Consumers  
Power  
Company

DOCKET 50-155, LICENSE DPR-6

## Request for Changes to the Technical Specifications

**BIG ROCK POINT PLANT**

CPCo DWG NO: FD55-CPPL-1, Rev A

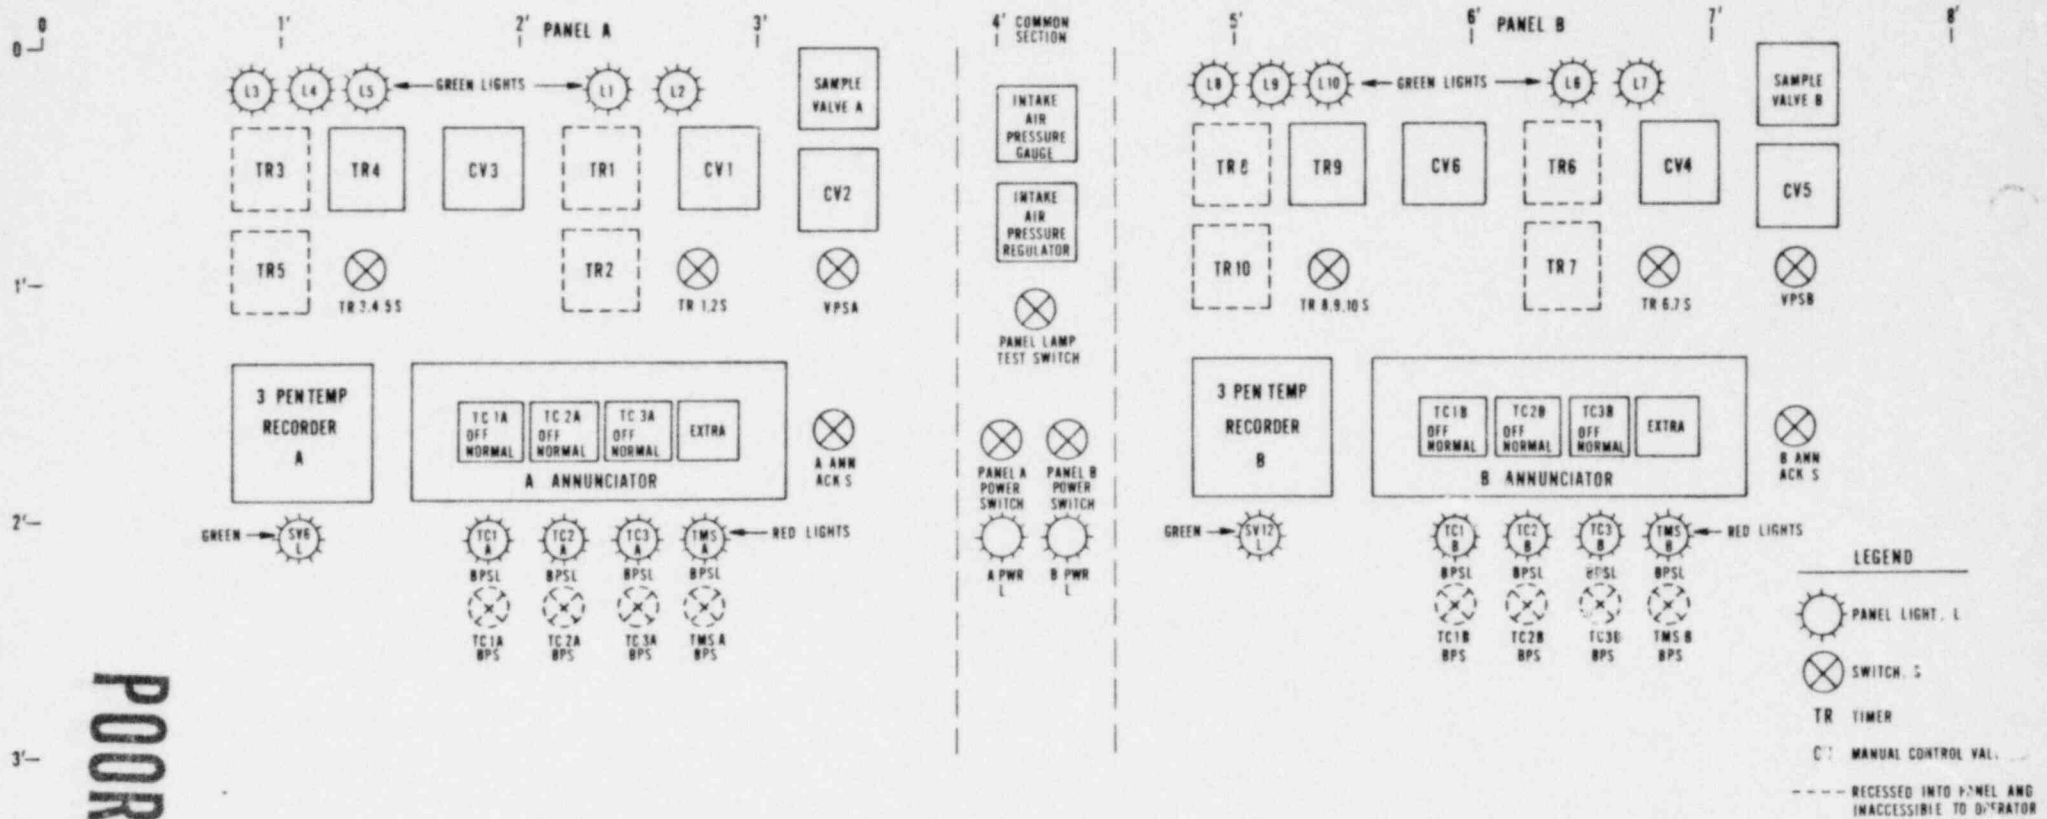
The design features are as follows (refer to Figures 1 and 2 attached):

1. The FDSS depends upon the water pressure differential (static head) between the fuel pool surface and the sipping can air/water interface level to provide the driving force for displacing the air from the sipping can at the conclusion of a sipping cycle (ie, when any or all of the valves SV-3, SV-4, SV-5, SV-6, SV-13, or CV-3 for Panel A are open or similarly, for these valves' counterparts in Panel B).

The FDSS uses multiple orifices at the lower level of the sipping can for water outlet when air is forced into the sipping can at the beginning of a sipping cycle. These same orifices provide water inlets when any one of the above valves is opened allowing reflooding of the can interior. These orifices provide a direct connection between the sipping can interior and the spent fuel pool. The possibility of a single inlet/outlet orifice becoming plugged by debris in the spent fuel pool, and subsequently preventing the desired flow of water, has been identified as a potential cause of abnormal fuel bundle heatup. Providing multiple (ie, redundant) inlet/outlet orifices, dispersed from each other to prevent a single piece of debris from blocking all orifices, is to prevent this incident. Periodic inspections of the inlets/outlets plus the good control of debris in the pool, combined with elevation of these orifices above the pool floor (the pool floor can be considered the ultimate receptacle for pool debris), make the probability of the simultaneous blockage of each of the water inlet/outlet ports for a sipping can negligible.

2. The possibility of the single air supply and air removal line on the sipping can becoming plugged, thus preventing removal of the air from the sipping can at the end of a cycle, has been identified as a problem that could possibly lead to fuel bundle overheating. To avoid the possibility of a single failure of this type causing an accident, a redundant line has been provided. Schematically, the two lines are in parallel and each line has its own primary iodine filter.

There is an unrestricted, continuously open crosstie between the two iodine filters. This crosstie shall allow flow to be automatically diverted from one iodine filter to the other as resistance to flow through either filter increases.

5. For protection against operator error relative to reflooding the can at the end of a given sipping cycle, timer actuated valves have been placed on the parallel reflood lines. The primary reflood timer (eg, TR-4 on Panel A) will be set at a time calculated specifically for each fuel bundle. The other two reflood timers (eg, TR-3 and TR-5 on Panel A) provide redundancy and additional protection against accidental overheating of a fuel bundle and will be set relatively conservatively for all bundles potentially available for sipping on at least a daily basis.

6. Protection against continual blowdown of the sipping can has been provided in the FDSS. Two timer actuated solenoid valves have been added in series on the air inlet line (eg, TR-1/SV-1 and TR-2/SV-2 on Panel A). This is to avoid possible overheating in the event the operator fails to isolate the sipping can from the inlet air. These timers operate the same as the timers in 5. above, relative to loss of power and cycle completion. These valves fail-closed upon loss of power.
